<u>ENGINE - HIGH PRESSURE TURBINE ROTOR AND STATOR ASSEMBLY - REMOVE THE STAGE 1 AND 2</u> TURBINE (INTERSTAGE FRONT OUTER) WIRE SEAL - CATEGORY CODE 6 - MOD.ENG-72-0158

# SERVICE BULLETIN

Location of the Stage 1 and 2 Turbine (Interstage Front Outer) Wire Seal Fig.2  $\,$

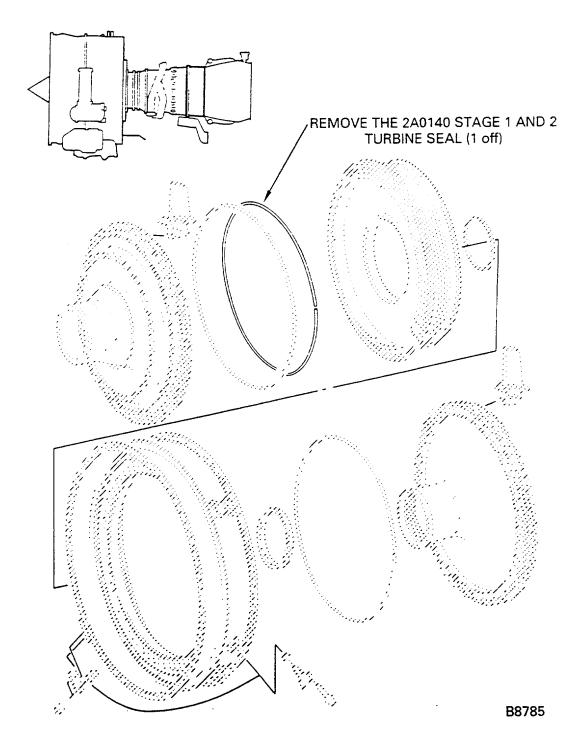
(1) When you assemble the HP Turbine Rotor and Stator Assembly by the approved procedure given in Reference (4), Control No./TASK No. 72-45-00-430-001-A00 or Control No./TASK No. 72-45-00-430-001-B00 do not install the Stage 1 and 2 Turbine (Interstage Front Outer) Wire Seal. See Figure 2.

(1) When you assemble the HP Turbine Rotor and Stator Assembly by the approved procedure given in Reference (4), Control No./TASK No. 72-45-00-430-001-C00 do not install the Stage 1 and 2 Turbine (Interstage Front Outer) Wire Seal. See Figure 2.
